PMC-2000627

PM4354 COMET-QUAD

COMET-QUAD REVISION A DEVICE ERRATA

ISSUE 2: SEPTEMBER 2000

2.1.4 Performance without workaround:

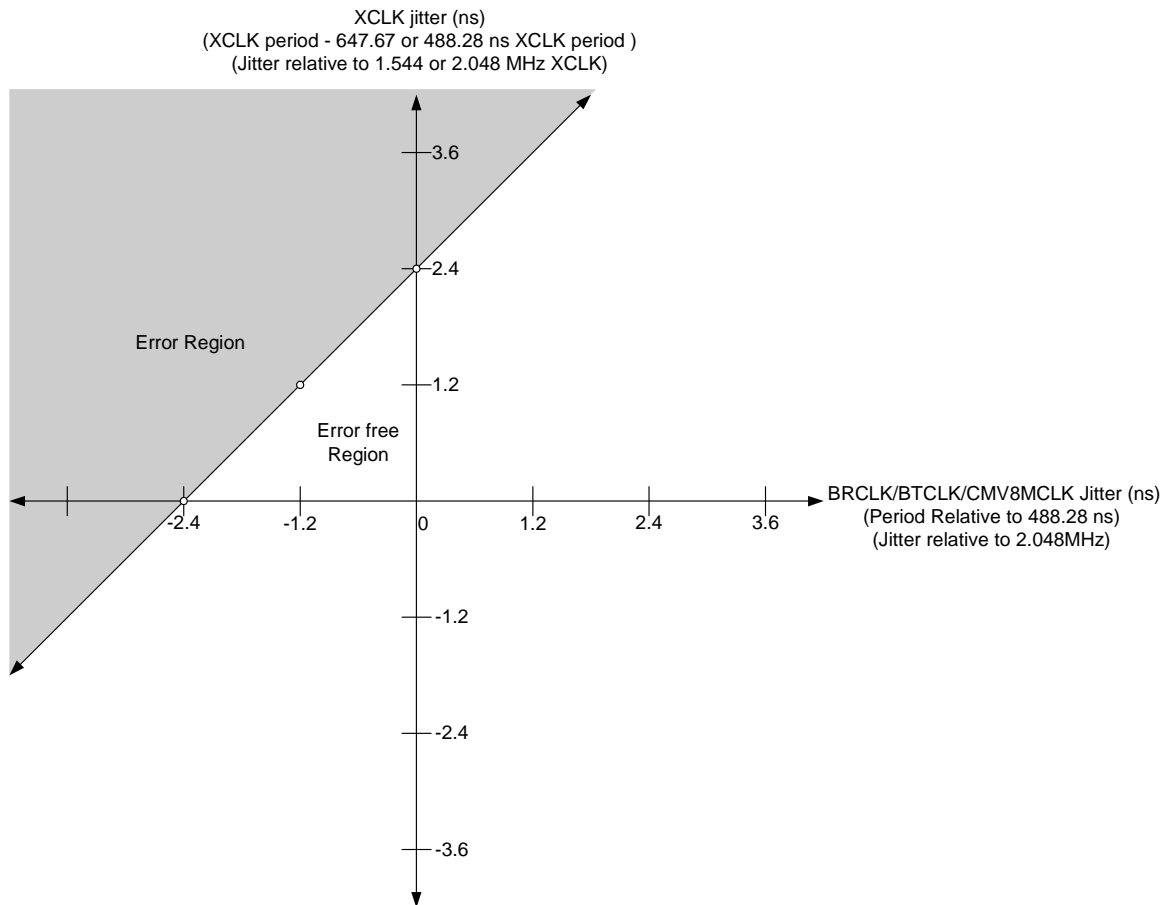
COMET-QUAD Revision A prototype parts will produce analog transmit pulses between 4 Vpp to 6.8 Vpp. The devices have not been trimmed to ensure compliance to the shorthaul/longhaul T1 pulse templates specified in ANSI T1.102, ANSI T1.403 and the E1 pulse templates specified in G.703.

Testing to standard pulse masks may result in failure to meet pulse template amplitude.

The next revision of the PM4354 COMET_QUAD will be trimmed to meet the T1 and E1 pulse templates over all specified temperature and voltage conditions.

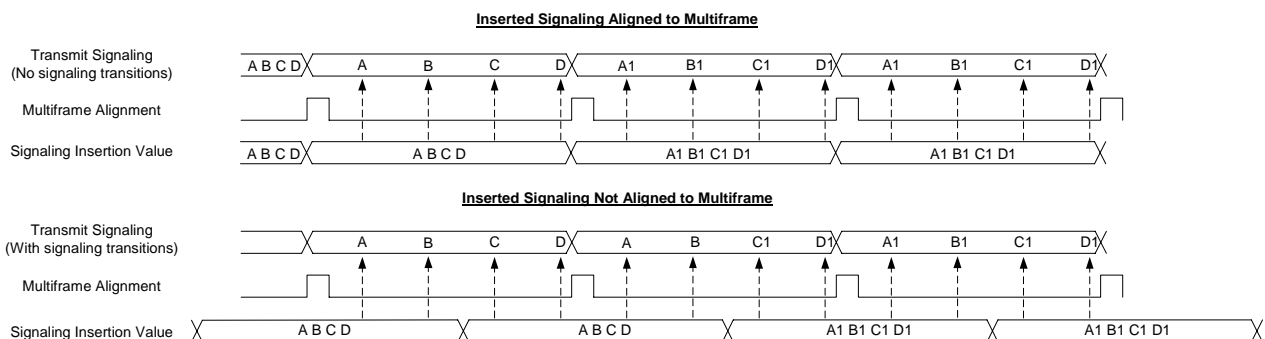
When the COMET-QUAD is configured for T1 mode with a slaved clock backplane (BRCLK[x], BTCLK[x] or CMV8MCLK (H-MVIP) are inputs) with a 2.048 MHz or greater backplane rate, the data and signaling information may be corrupted if the BRCLK[x], BTCLK[x], CMV8MCLK and XCLK jitter (defined as instantaneous worst case period) is not tightly controlled. The following diagram shows the error and error-free operating regions when in the presence BRCLK/BTCLK/CMV8MCLK and XCLK jitter.

The BRCLK/BTCLK/CMV8MCLK jitter is described as the worst case instantaneous peak jitter relative to a jitter-free BRCLK/BTCLK/CMV8MCLK. The XCLK jitter is described as the worst case instantaneous peak jitter relative to a jitter-free XCLK. The jitter for both XCLK and BRCLK/BTCLK/CMV8MCLK are described as positive and negative peak jitter in nanoseconds (ns). Positive peak jitter increases the instantaneous period while negative peak jitter shortens the instantaneous period.

When the COMET-QUAD is a backplane clock slave, BRCLK[x], BTCLK[x] and CMV8MCLK are inputs. BRCLK[x] and BTCLK[x] can be 1.544, 2.048, 3.088, or 4.096 MHz. When at 3.088 or 4.096MHz, the clocks are internally divided down by a factor of two. CMV8MCLK is internally divided down to 2.048MHz. The above diagram represents the internally divided down clocks.

Proper operation is ensured when the worst case instantaneous XCLK jitter minus the worst case instantaneous BRCLK/BTCLK/CMV8MCLK jitter is less than 2.4ns through all valid voltage and temperature ranges (XCLK jitter – BRCLK/BTCLK/CMV8MCLK jitter < 2.4). The following are example configurations that allow the COMET-QUAD to operate error free.

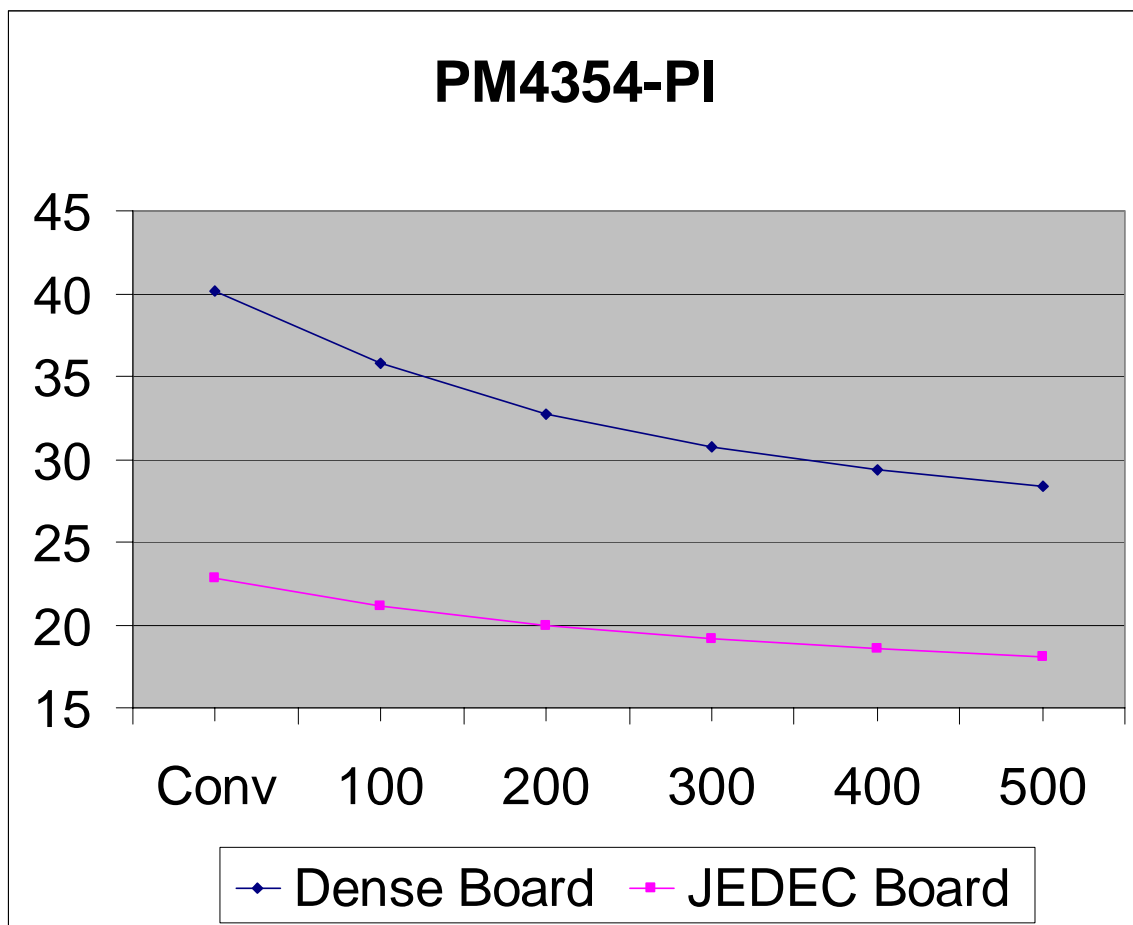
The Ordering and Thermal Information section of the data sheet should be changed to correctly describe the COMET-QUAD thermal information. Also, a graph of Theta J-A with respect to Forced Air, should be added.

3. – For long-term reliability, it is recommended that the junction temperature should remain below 105 degrees Celsius.
